## SUBDIVISION REVIEW SHEET

**CASE NO.:** C8-2020-0193

**SUBDIVISION NAME:** Wildhorse Tract B, Section 1

**CITY OF AUSTIN –DEVELOPMENT SERVICES DEPARTMENT  
SUBDIVISION APPLICATION – MASTER COMMENT REPORT**

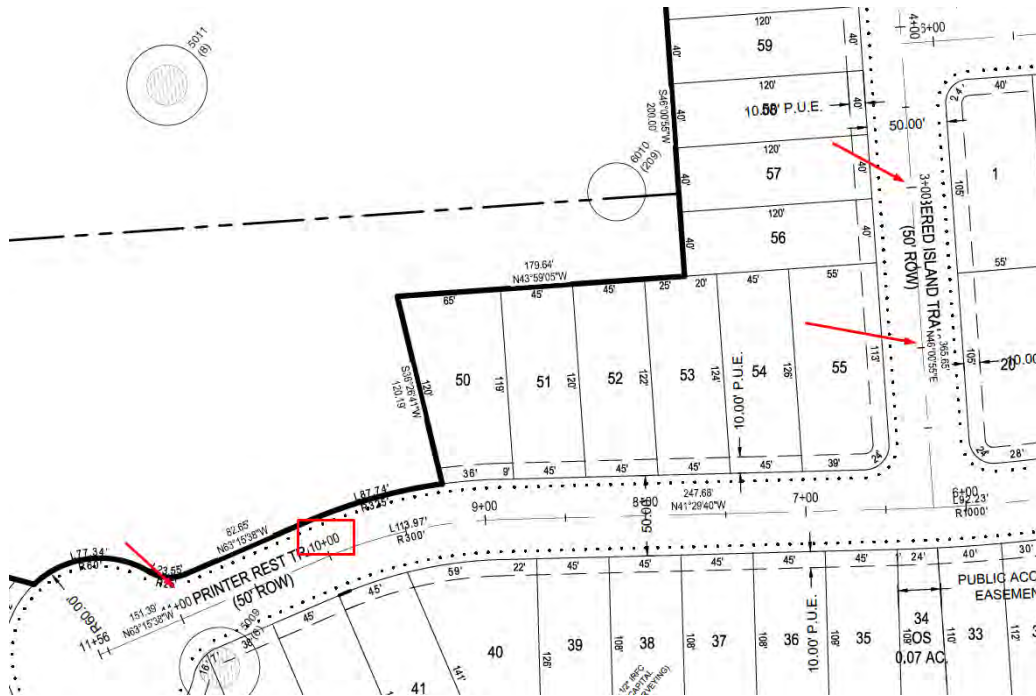
AD2: Please provide an overall page with all the proposed street names without labels on the names. Email [addressing@austintexas.gov](mailto:addressing@austintexas.gov) to have your street name candidates reviewed and reserved with the subject line: Street Name Case Number Project Name

Example: Street Name C8-2021-0152.2A Pinnacle at Wildhorse Ranch Section 2
